Donald C. Cook Nuclear Plant Unit 1 and Unit 2
REVISED RESPONSE TO REQUEST FOR ADDITIONAL INFORMATION
REGARDING RELAXATION OF REACTOR PRESSURE VESSEL HEAD
PENETRATION INSPECTION REQUIREMENTS IN NUCLEAR
REGULATORY COMMISSION ORDER

ATTACHMENT 1 TO AEP:NRC:3054-08

REVISED RESPONSE TO REQUEST FOR ADDITIONAL INFORMATION

Sketch of D.C. Cook Unit 2 Reactor Vessel Head Penetration
(Not to Scale)

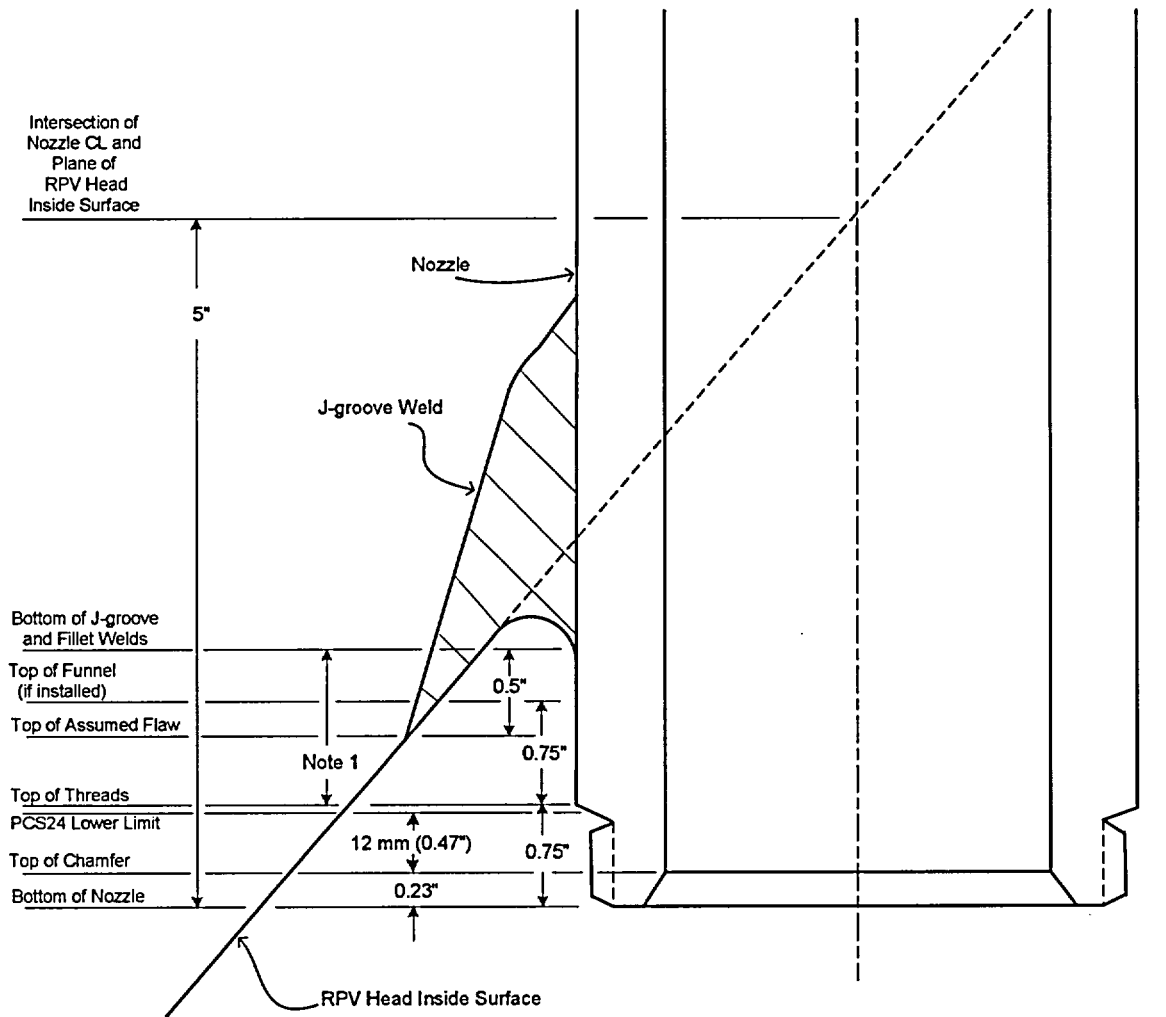
The licensee stated that a small portion of base material will not be scanned on the bottom of the nozzle because the lower transducer and the upper transducer of the probe need to be in contact with the nozzle material. The distance from the bottom of the nozzle upward that cannot be scanned is 12 mm. Please identify the minimum distance from the J-groove weld to the location on the nozzle that cannot be scanned.

The licensee is requested to provide a sketch of the nozzle with the necessary dimensioning to clarify the areas covered by the request.

Provide the distance from the bottom of the weld to the point where ET/PT cannot be performed.

As shown in the sketch provided at the end of this attachment, the distance from the bottom of the nozzle upward that cannot be scanned due to the PCS24 probe transducer arrangement has been calculated to be 12 millimeters (0.47 inches) plus the height of the chamfer (0.23 inches). The minimum distance downward from the J-groove weld to the location on the nozzle that cannot be ultrasonically scanned due to the PCS24 probe transducer arrangement has been calculated to be approximately equal to the minimum inspectable distance resulting from the external threads on the nozzle. As described in the response to NRC Question 3, with one exception, the minimum inspectable distance resulting from the external threads has been determined to be 0.68 inches, based on best estimates by personnel reviewing ultrasonic inspection results. The one exception is discussed in the response to NRC Question 3.

A sketch has been provided at the end of this attachment.

The nozzles that have guide funnels installed are the outermost nozzles. As shown in the sketch provided with this attachment, the guide funnels extend approximately 0.75 inches above the threads. Consequently, the minimum distance from the J-groove weld to the location on the nozzle that cannot be examined by eddy current testing or dye penetrant testing on nozzles that have funnels installed is less than the distance assumed in the crack growth calculation described in the response to NRC Question 2 in Part 1. Although the portion of the funnel extending 0.75 inches above the threads precludes eddy current testing and dye penetrant testing, it does not preclude ultrasonic inspection, which is performed from the inside. Therefore, this area of the nozzles having guide funnels would be inspected ultrasonically.

Note 1: The minimum distance from the bottom of the J-groove and fillet welds to the top of the threads (except for penetration 73) is 0.68." - This occurs on the downhill side of one penetration. For penetration 73, the minimum distance from the bottom of the J-groove and fillet welds to the top of the threads is 0.36." The OD of Penetration 73 was dye penetrant tested to the bottom of the nozzle and the OD was eddy current tested to the top of the chamfer. The distances from the bottom of the J-groove and fillet welds to the top of the threads are based on best estimates by personnel reviewing ultrasonic inspection results.

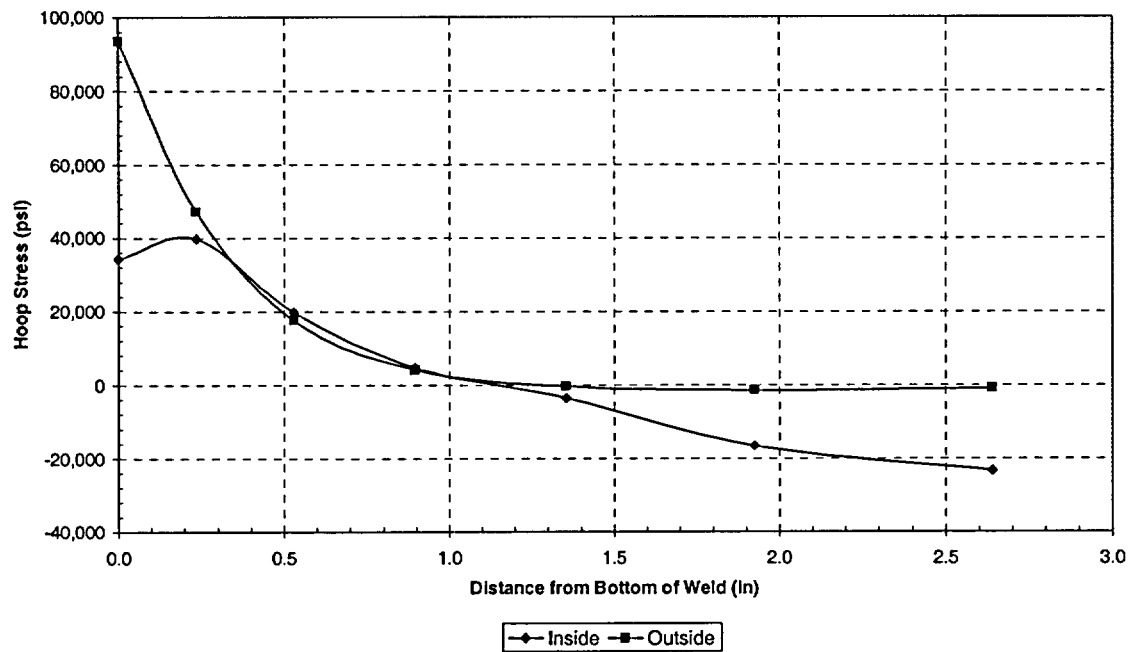
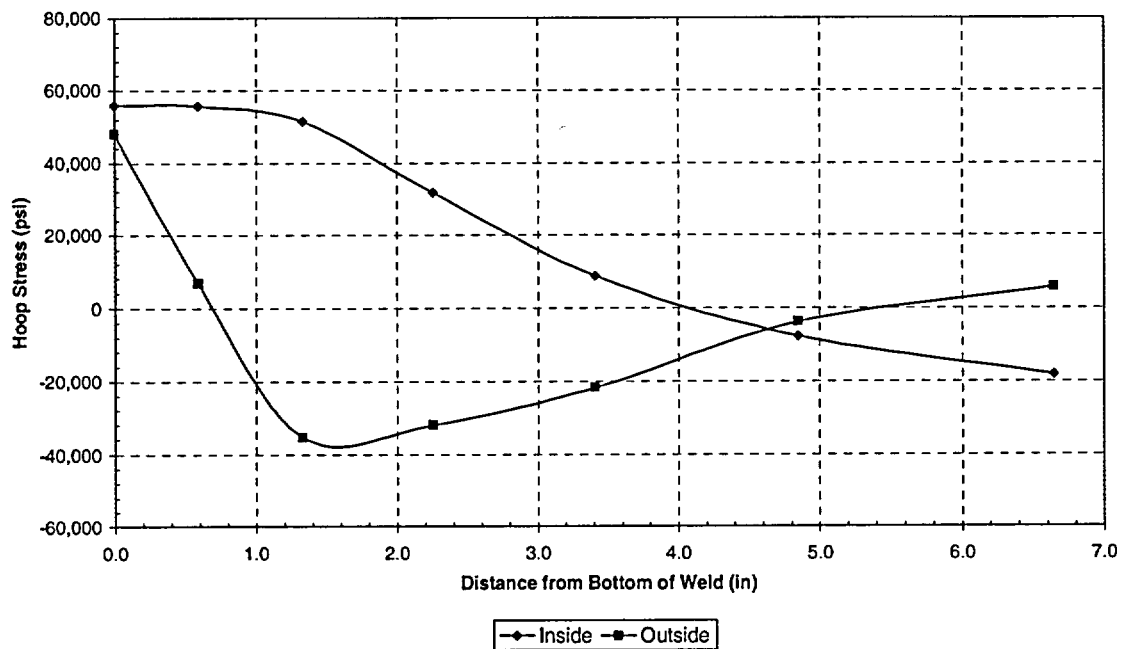
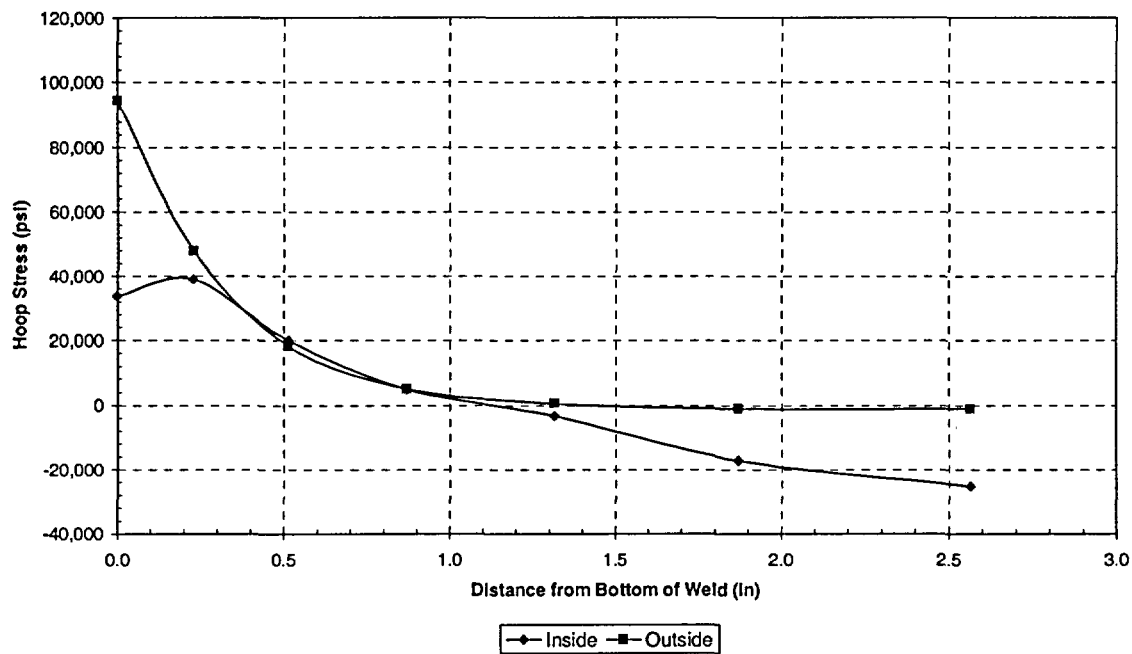
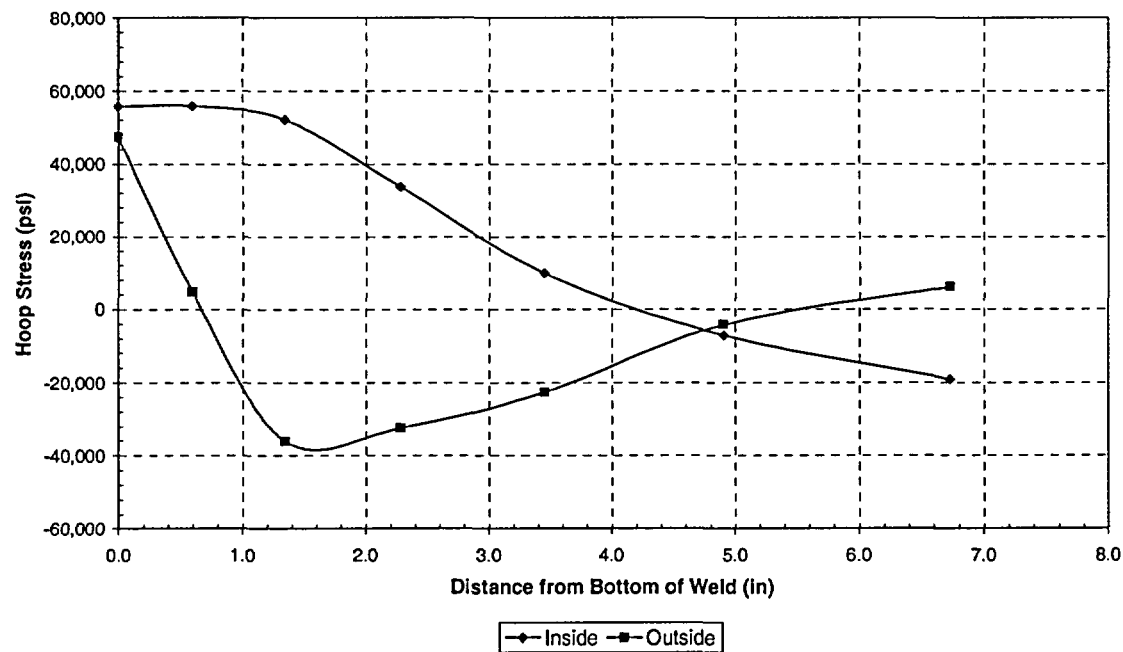
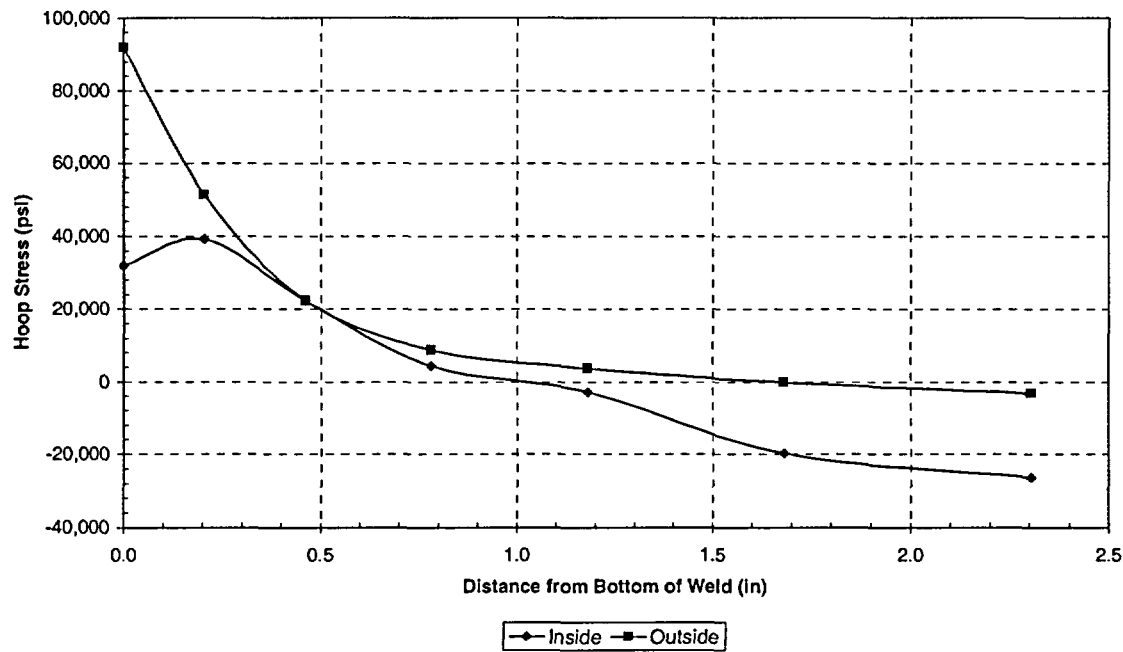
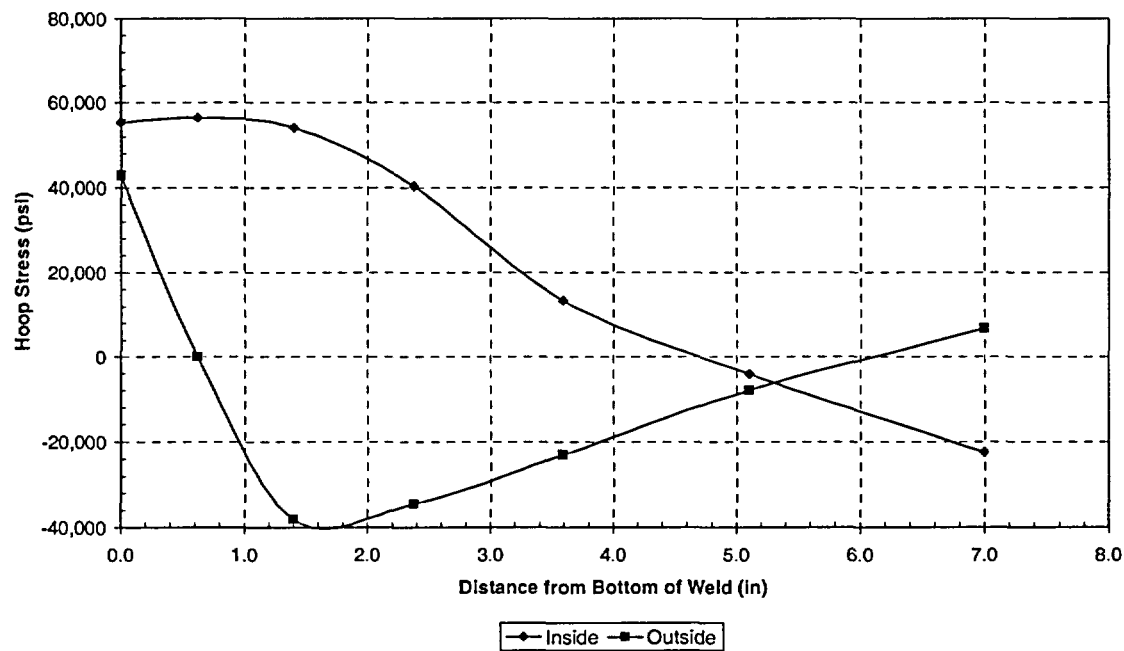
Provide additional technical justification (i.e., operating stress levels, crack growth analysis, etc.) that supports the licensee's statement that the small area that cannot be scanned is insignificant to the phenomena of concern.

The steady state and residual stresses in that area are shown in Attachment 2 to this letter, which provides graphs of hoop stress versus distance below the J-groove weld for various nozzles from the center of the Unit 2 RPV head to the outermost row. As shown in these graphs, the stresses in the area of the nozzle that would not be inspected are low relative to the yield stress of the nozzle material (41,000 to 63,000 pounds per square inch).

The calculations were performed for the three outer penetration rows (45.8°, 47.0°, and 50.5° in Attachment 2). The results of these calculations are illustrated by the four crack growth curves provided in Attachment 3 to this letter. The first three curves show that it would take more than 2.3 effective full power years for the postulated flaw 0.5 inches below the J-groove weld to propagate to the bottom of the weld. This time period is more than the minimum under-head inspection interval for Unit 2 (one operating cycle) required by NRC Order EA-03-009. For rows other than the three outer rows, the inspectable length exceeds 1 inch, based on best estimates by personnel reviewing ultrasonic inspection results. The 1 inch inspectable length provides a conservative factor of 2 with respect to the crack growth distance assumed in the calculations. The effect of additional inspectable length on crack growth times is illustrated by a comparison of the first and fourth curves in Attachment 3. These curves show that an increase in inspectable length of 0.18 inches results in an increase of approximately 4 effective full power years in the time it would take a flaw in the uninspectable area to reach the J-groove weld for the third outermost row.
